# HIDEOUT, UTAH TOWN COUNCIL REGULAR MEETING

May 28, 2020

**Staff Report – Engineering Department  
Town of Hideout Planning Commission**

**Date:** April 28, 2020  
**Applicant:** Nate Brockbank  
**Subject:** Deer Springs Phase 1 Plans – Amended  
**Recommendation:** Final Approval

**(Revised Phasing Map)**

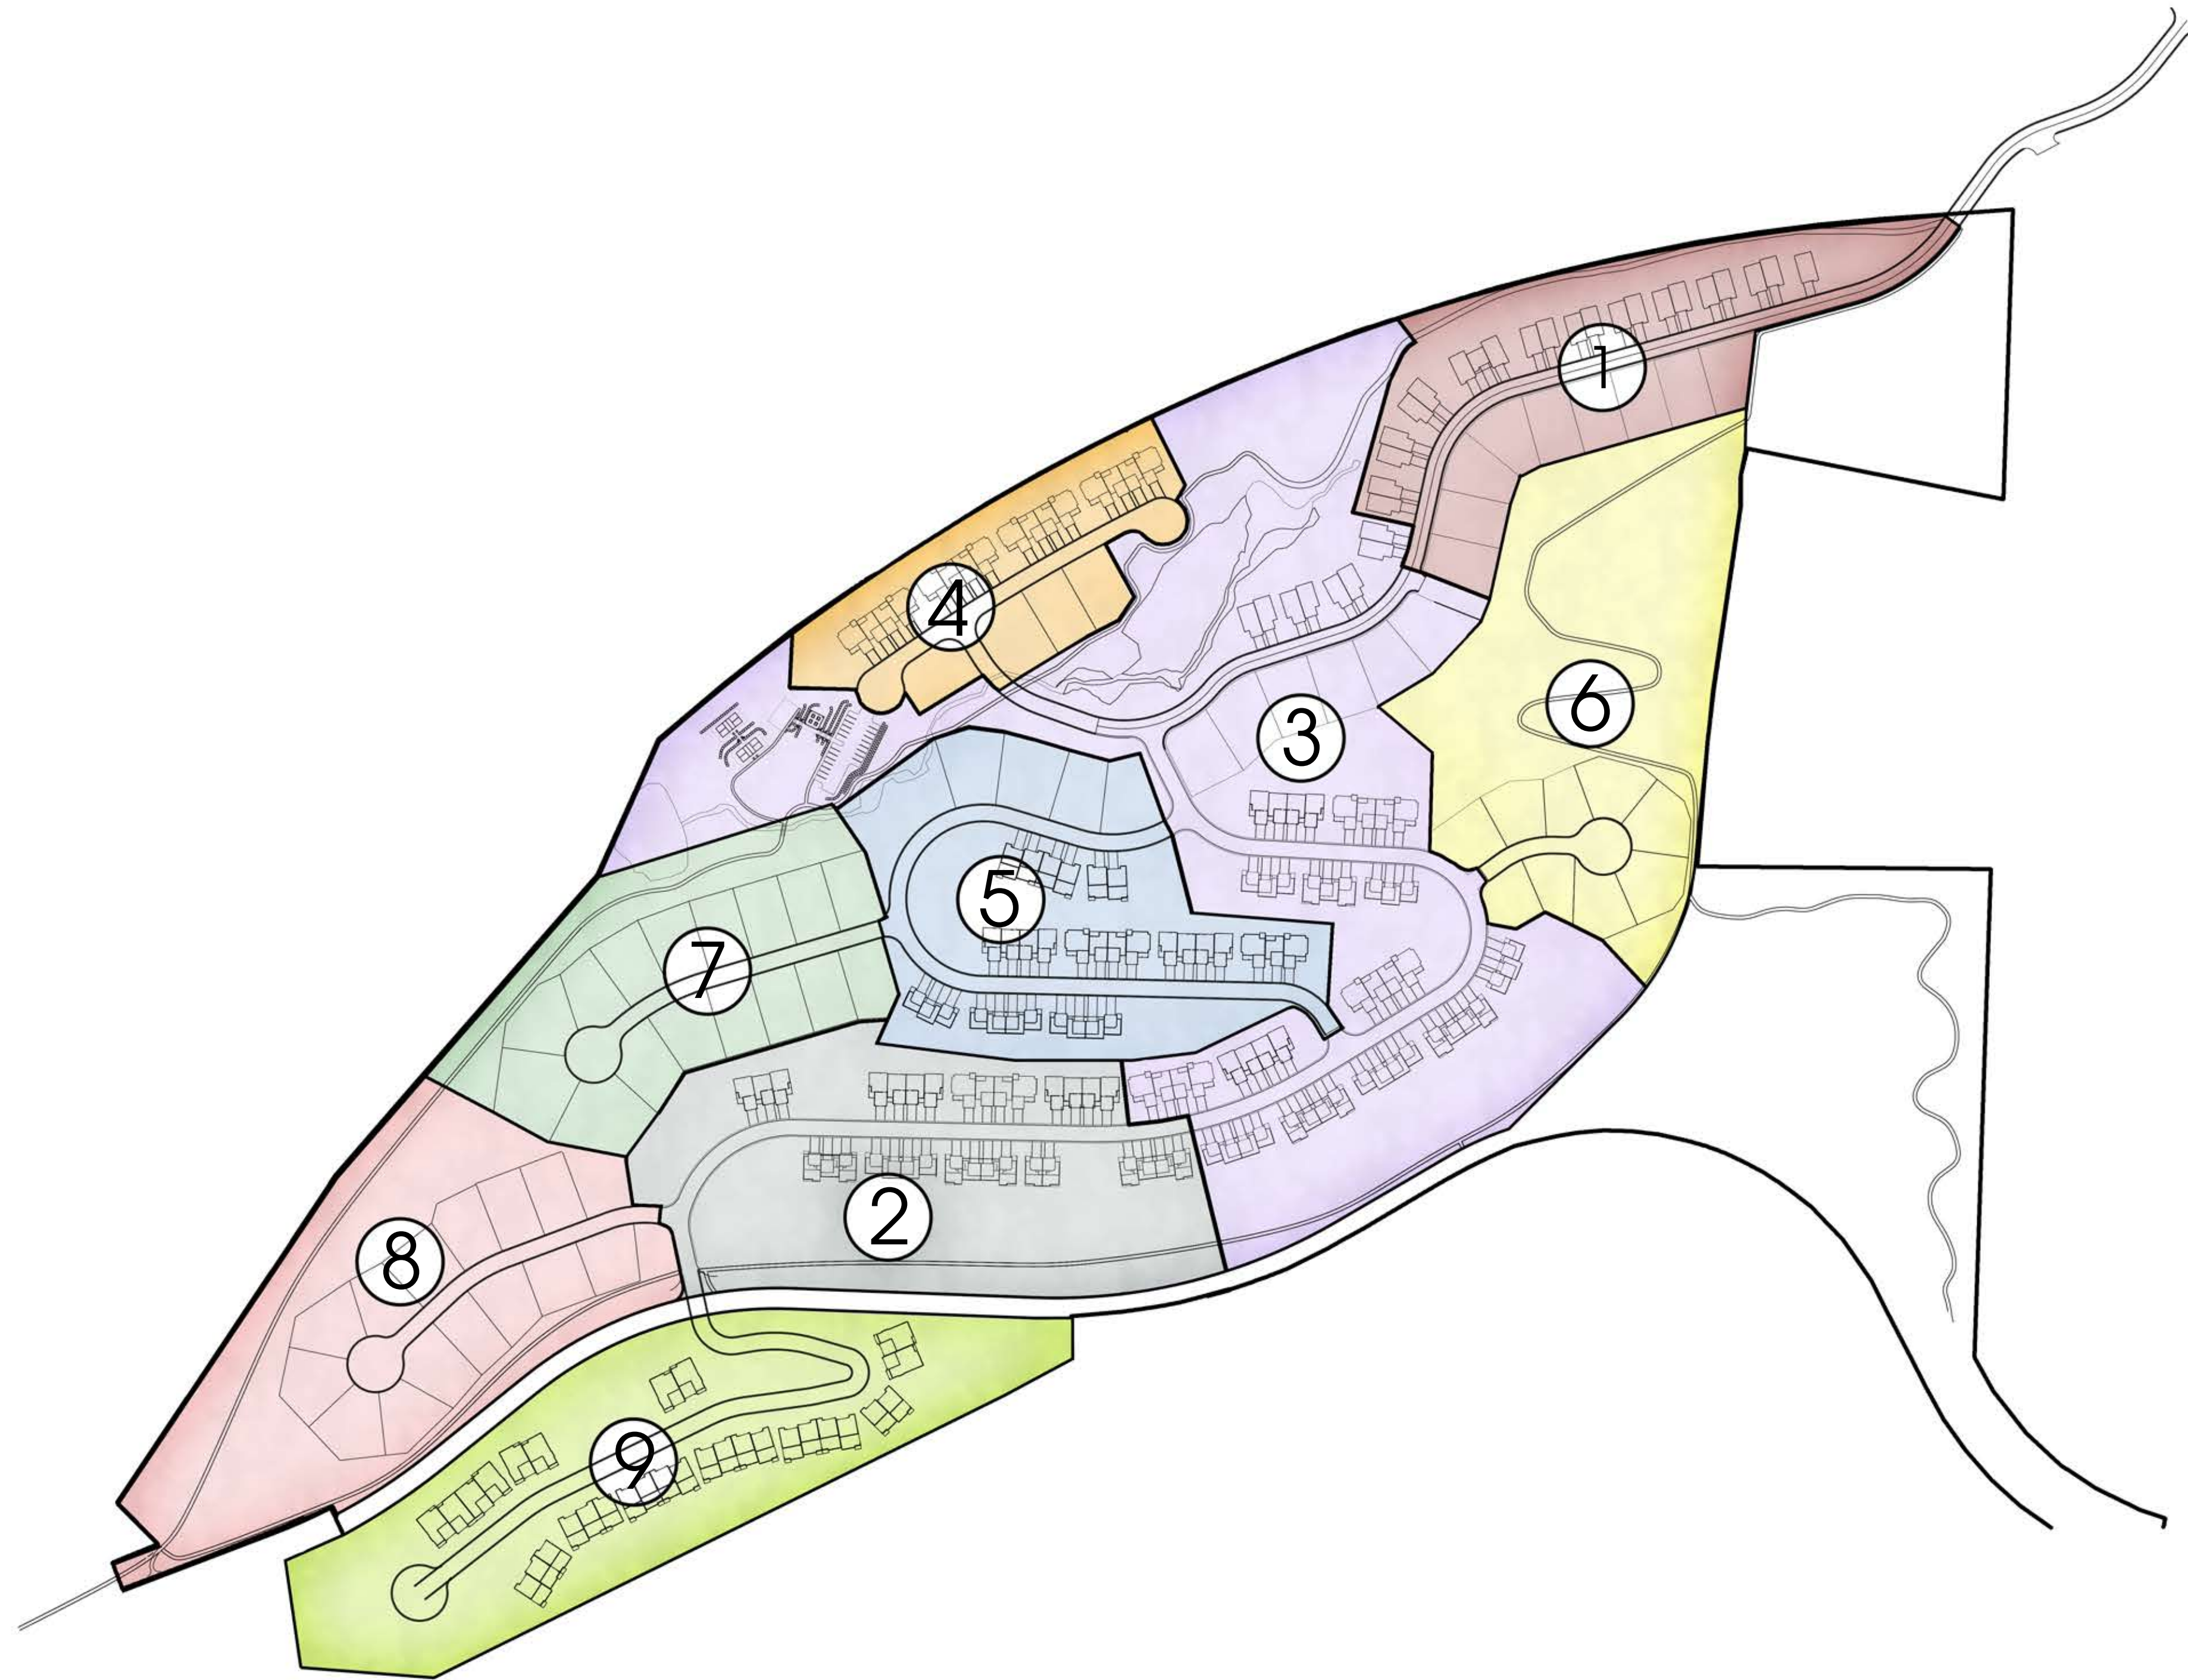
3. **Amendment to Phasing Plan.** The Phasing Map, attached as Exhibit B-2 to the MDA, is hereby deleted in its entirety and replaced with Exhibit B-2.1, attached to this First Amendment. For all purposes under the MDA, references to the Phasing Map shall, hereafter, mean and refer to Exhibit B-2.1, attached hereto. For the avoidance of doubt, sixteen (16) of the single family home sites which were shown within Phase 1 on Exhibit B-2 (the original Phasing Map) will be moved to what is now Phase 7 as shown Exhibit B-2.1, attached hereto. Likewise, the twenty-eight (28) townhome sites which were shown within Phase 5 on Exhibit B-2 (the original Phasing Map) will be distributed among what are now referred to as Phase 1 and Phase 3 as shown on Exhibit B-2.1. The revised Phasing Map shown as Exhibit B-2.1 also contains other changes to the distribution of units among the Phases as compared to Exhibit B-2 (the original Phasing Map). However, the Maximum Residential Units have not changed, and Developer will construct no more than one hundred eighty-eight (188) Townhome units and no more than sixty (60) detached single family units. Notwithstanding the foregoing, when Developer submits final Plats for the Project, Developer may elect to pursue less density for each phase than is currently illustrated on Exhibit B-2.1.

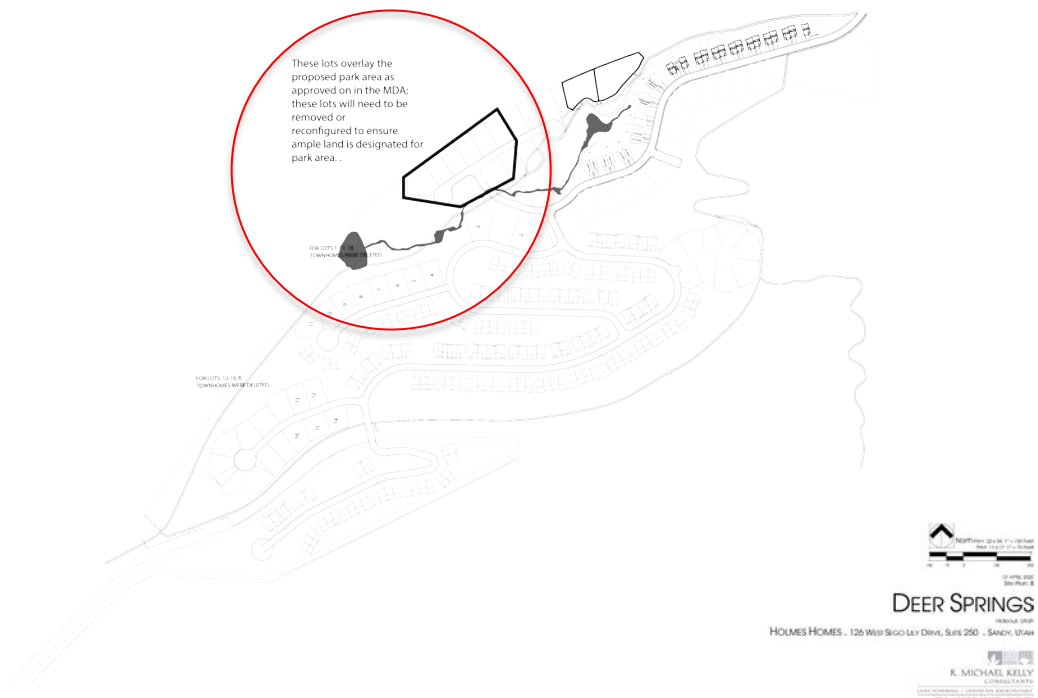
- The Applicant submitted updated plans proposing to:
  - Remove sixteen (16) single-family houses from Phase 1 (the upslope side of Bellaview Way) and replace them with 30 townhouses
  - The 16 single-family houses would then replace the 30 townhouses in a subsequent Phase. Applicant to confirm which Phase these units will be incorporated into.
  - No change to the overall density of Deer Springs is proposed.
  - No additional changes to the site plan or plat are proposed other than the requirement for additional utility and service connections.
- The plan set is missing:
  - Heights and locations of all proposed retaining walls
  - A structural analysis of these walls must be provided
  - A section of a typical tiered wall must be provided including materials, planting in the horizontal breaks, etc.

- Each drive lane for the entire Deer Springs development is illustrated at 13.5' wide; per recent recommendations by the Town Planner and Engineer, a paved bike lane shall be incorporated into all new rights-of-way construction.

UTILITY PLAN

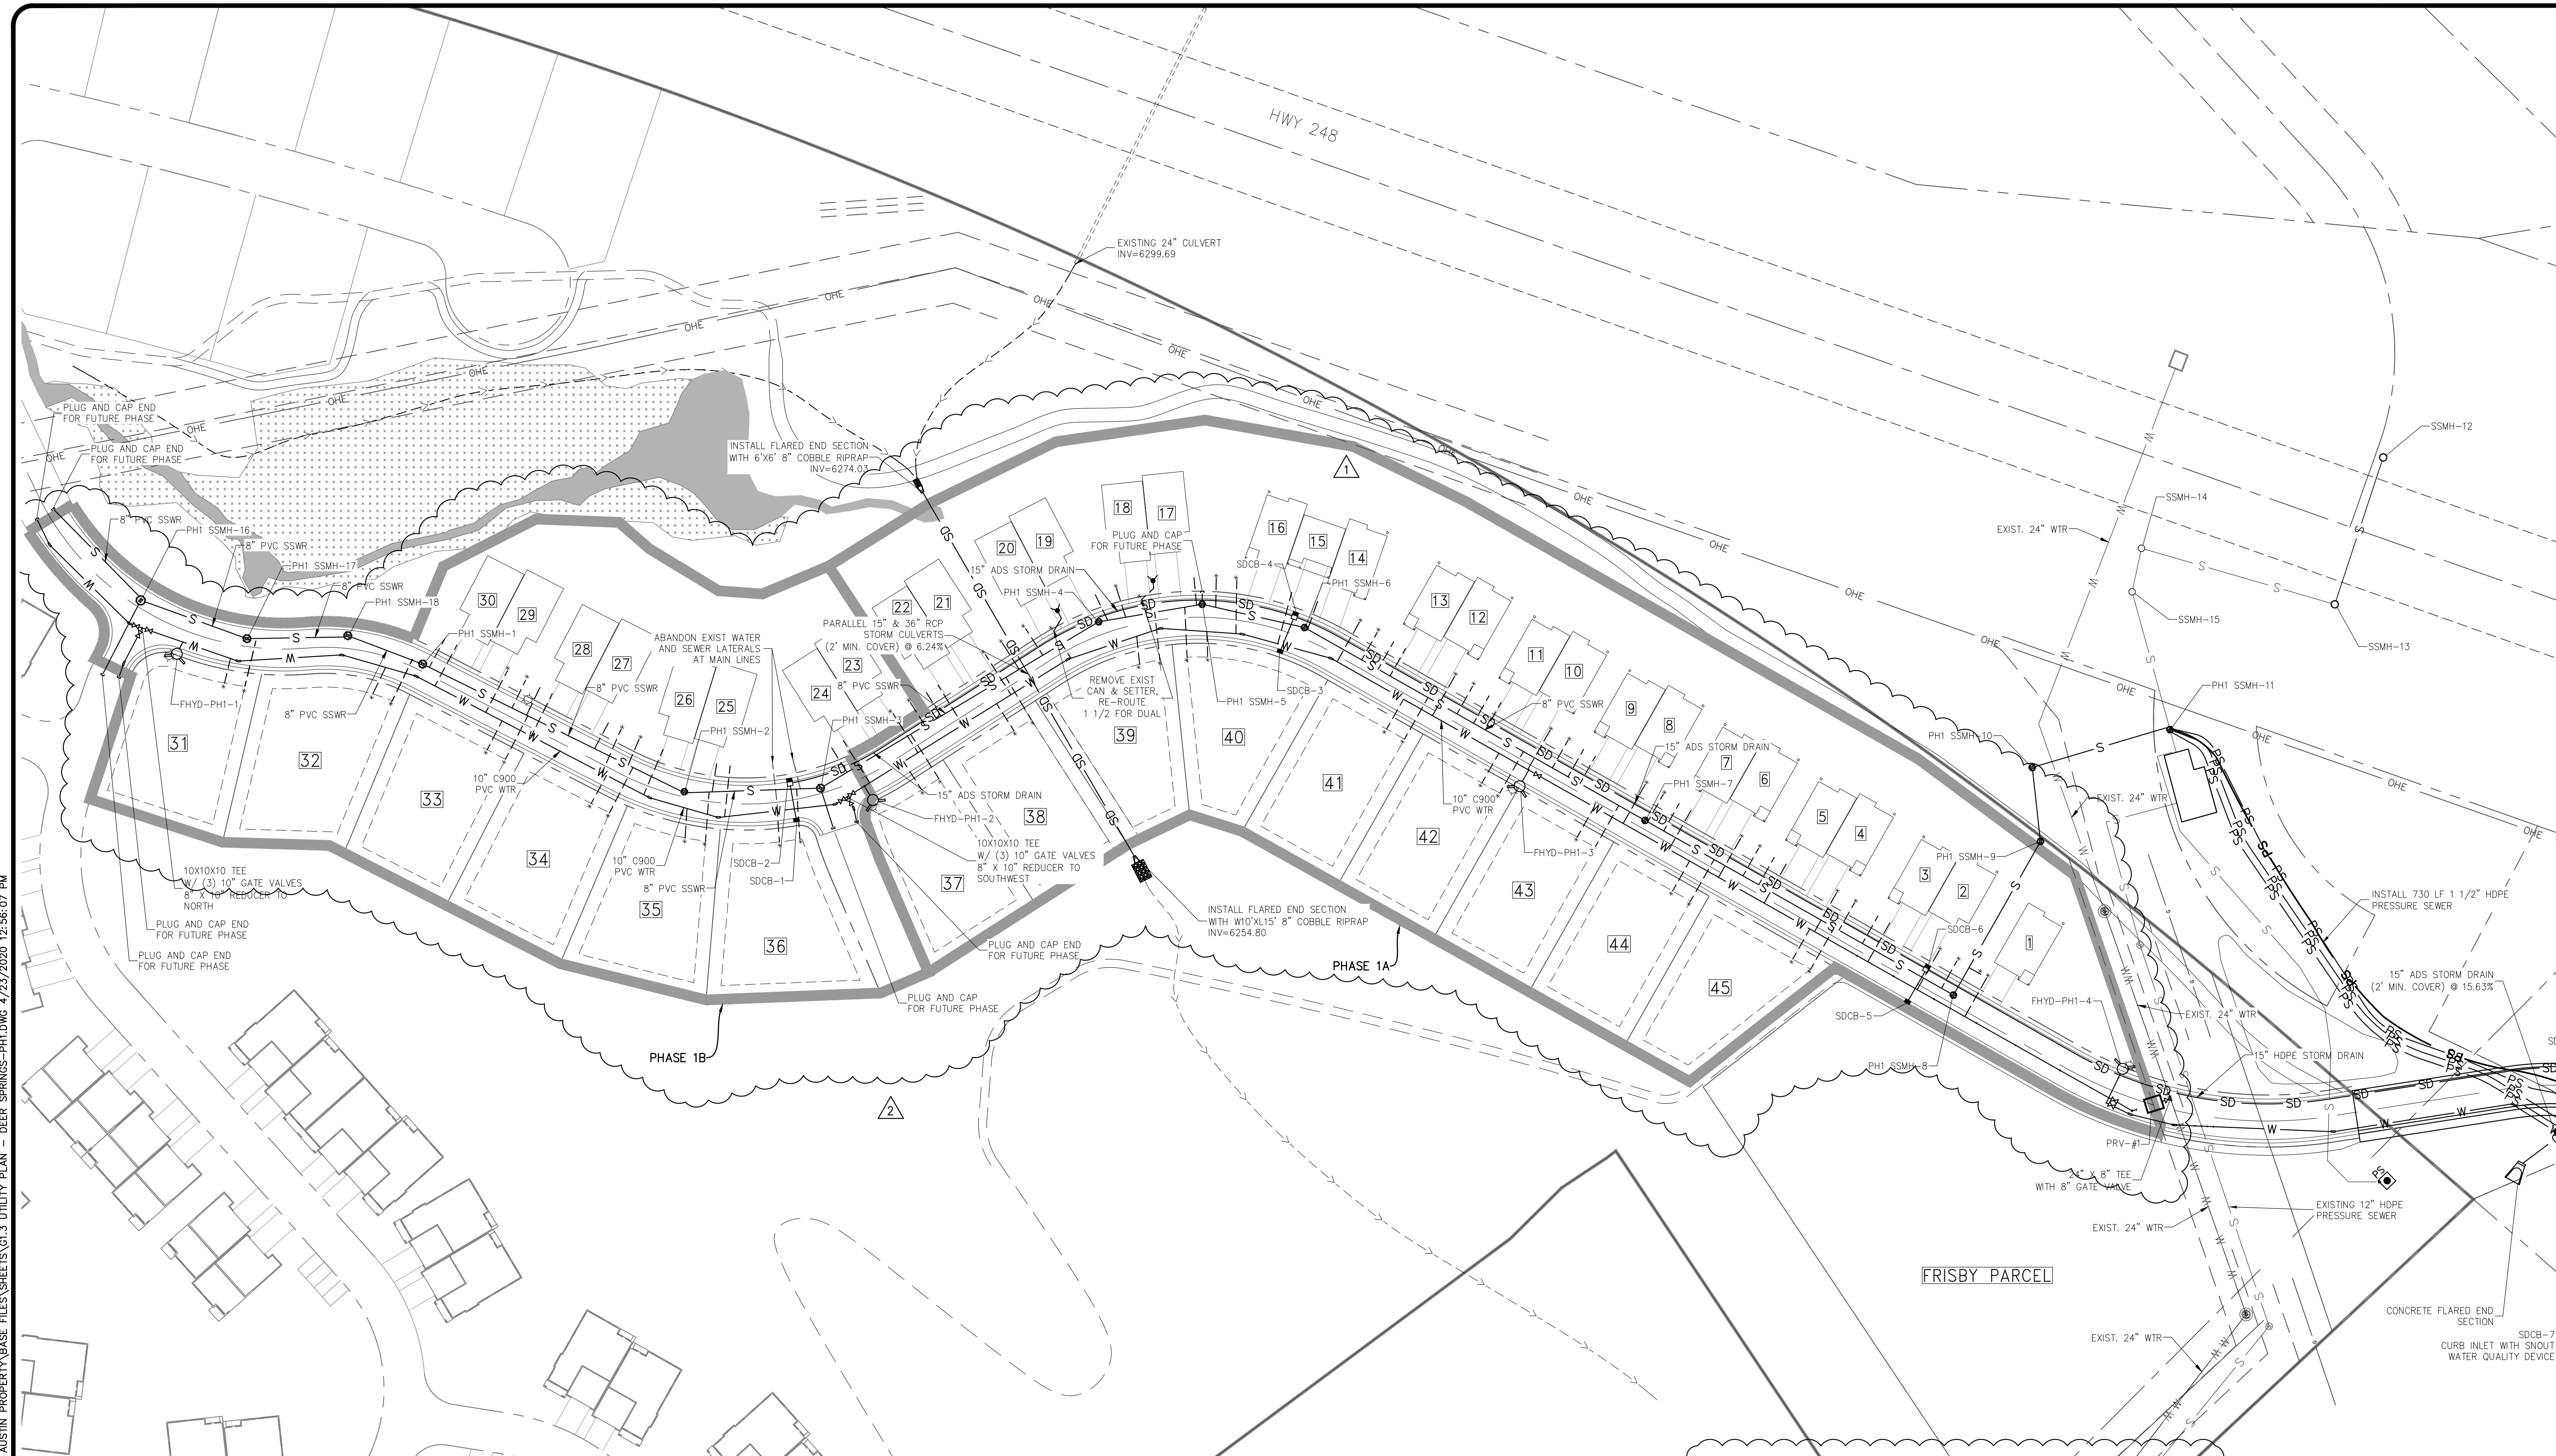
The change in housing necessitates some change and a significant increase to the water and sewer line utility service laterals. The plan involves the installation of 28 new water/sewer laterals (according to our count). This involves digging in much of the already-prepared roadway subgrade. The emphasis on testing and meeting Town code is therefore added as a condition of approval.
